Project	<b>IEEE 802.16 Broadband Wireless Access Working Group</b> < <a href="http://ieee802.org/16">http://ieee802.org/16</a> >	
Title	<b>Pre IP allocation by PKM</b>	
Date Submitted	<b>2004-08-16</b>	
Source(s)	Koohyun Um, Sangkwon Ahn, _ Chanyong Park, Taewook Moon, _ Pyungsu Park, Keunhyung Park	Voice: +82 2 6266 5288  Fax: +82 2 6266 5309 <a href="mailto:petitchien@hanaro.com">petitchien@hanaro.com</a>
	Hanaro Telecom Inc. 470-9 Shindaebang-dong, Dongjak-Gu, Seoul, Korea 156-010	
Re:	IEEE P802.16 REVe/D4-2004	
Abstract	This contribution presents a method for pre IP allocation by PKM.	
Purpose	Review and adopt the suggested changes into P802.16e/D4	
Notice	This document has been prepared to assist IEEE 802.16. It is offered as a basis for discussion and is not binding on the contributing individual(s) or organization(s). The material in this document is subject to change in form and content after further study. The contributor(s) reserve(s) the right to add, amend or withdraw material contained herein.

# Pre IP allocation by PKM

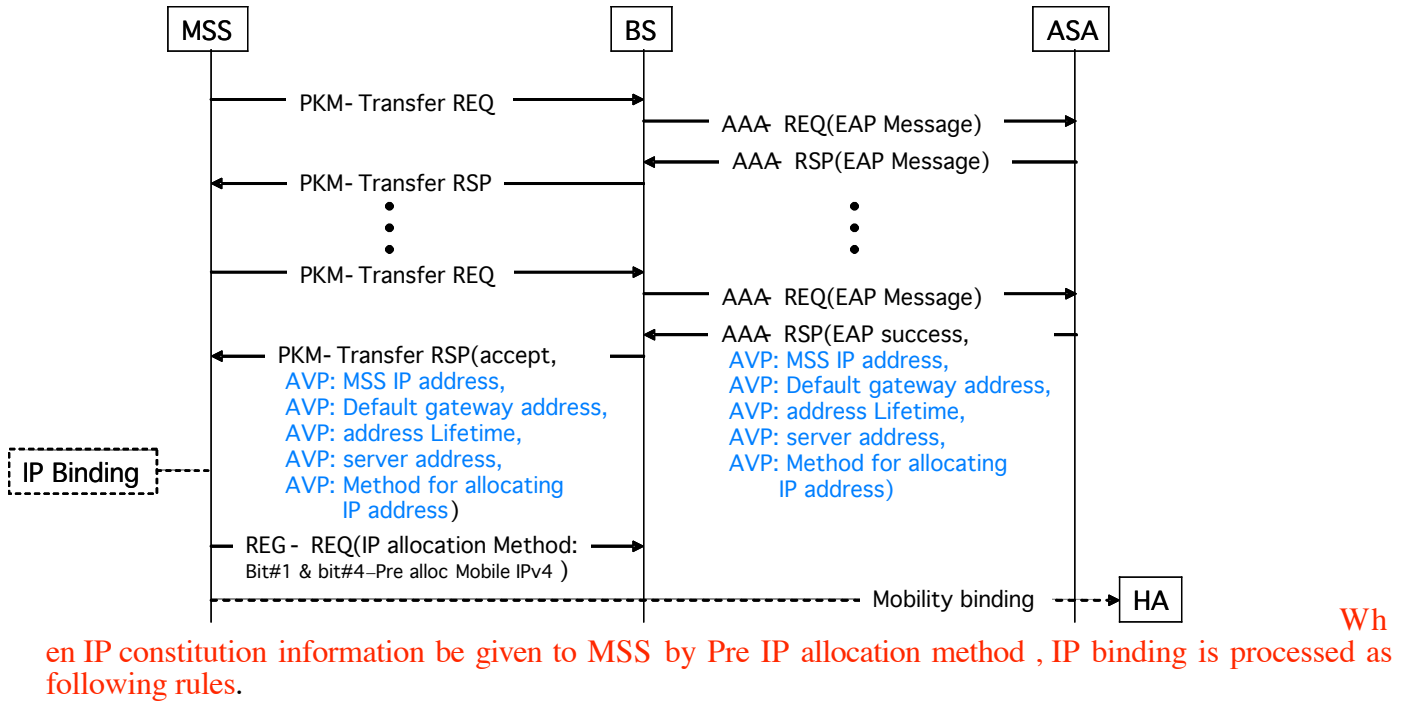
**for an MSS, if pre-IP-allocation by PKM is being used, the MSS skip the establishment of IP connectivity step. Method for pre-IP-allocation by PKM is described in section 9.1.3**

**For IP allocation using DHCP or Mobile IP, MSS shall be given an IP constitution information in PKM-REQ/RSP process which is an authentication process to BS.**

**The following is the flow of pre IP allocation method.**
